7.1.2 176-180 KANGAROO ROAD HUGHESDALE- TPA/55532- USE AND CONSTRUCTION OF A TWO STOREY CHILDCARE CENTRE WITH BASEMENT CAR PARK, DISPLAY OF SIGNAGE AND REDUCTION OF CAR PARKING REQUIREMENT

That Council resolves to issue a Notice of Decision to Grant a Planning Permit TPA/55532 for the use and construction of a two-storey childcare centre with basement car park, display of a business identification sign and reduction of car parking requirement at 176-180 Kangaroo Road Hughesdale subject to the following conditions:

Location of fencing required

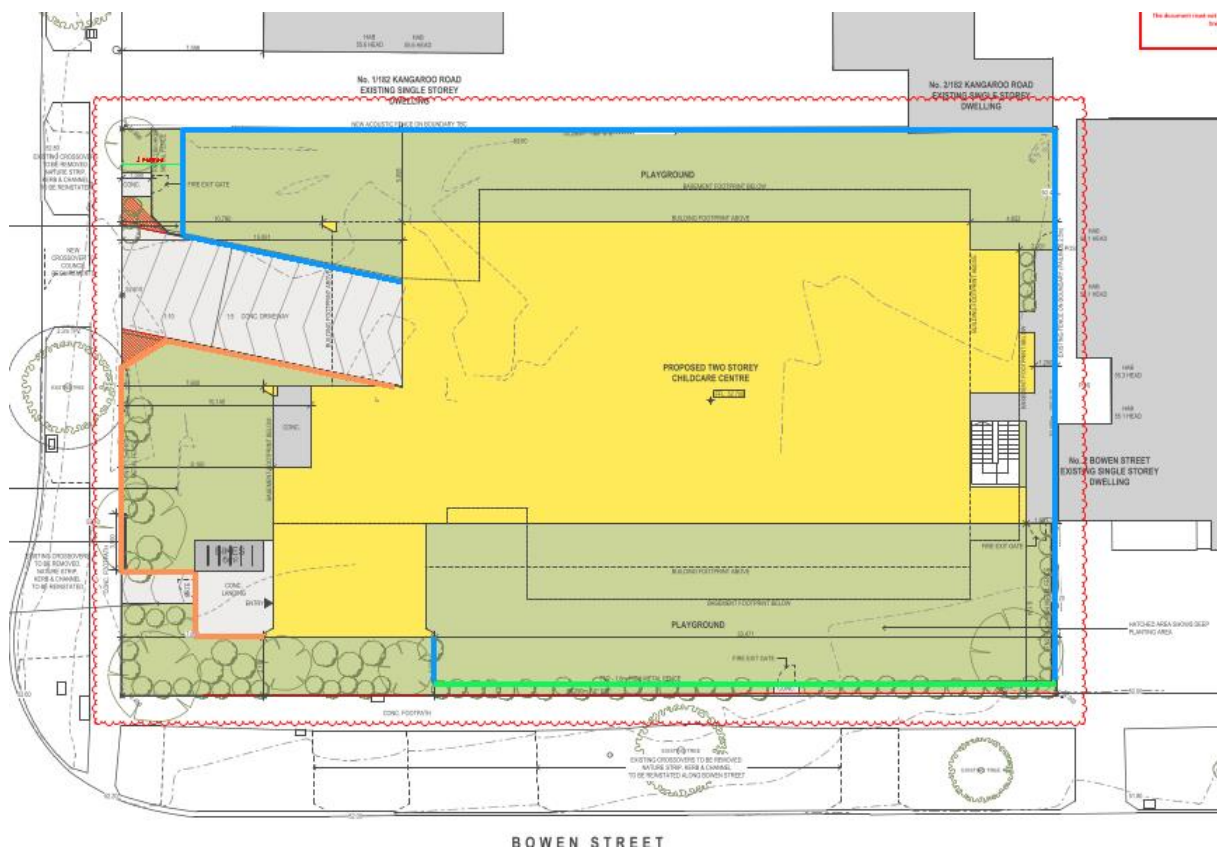
Should the application be supported, conditions of approval will require changes to the fencing as proposed, given the need for acoustic measures to be integrated into the fencing as recommended by the Acoustic Report which has been prepared. The plans show 1.8 metre high fencing, however, the acoustic report requires that fencing surrounding the playground areas should be increased in height to 2.4 metres, and are required to be constructed of timber or corrugated iron.

Given this, it is recommended that the fence fronting Bowen Street introduce an element of transparency such as Perspex 'windows' to allow for some visibility through the fence into the play space. The fence is set back 1 metre from the street which will allow for planting in front to soften the high front fence from the street. Neighbourhood character guidelines discourage fences over 1.2 metres. Noting that this is a corner site and it is not unreasonable for a high paling fence to be built on a side street to screen secluded private open space.

The image below represents the location of fencing as per the proposed conditions of the permit to ensure that the fencing fits with the existing and preferred character of the area and allows for the building to sit within a landscaped setting.

The blue line represents a 2.4m high timber acoustic fence. The green line represents a 2.4m high timber acoustic fence with transparent elements (window like features with Perspex) and the orange line represents a 1.2m high metal picket fence.
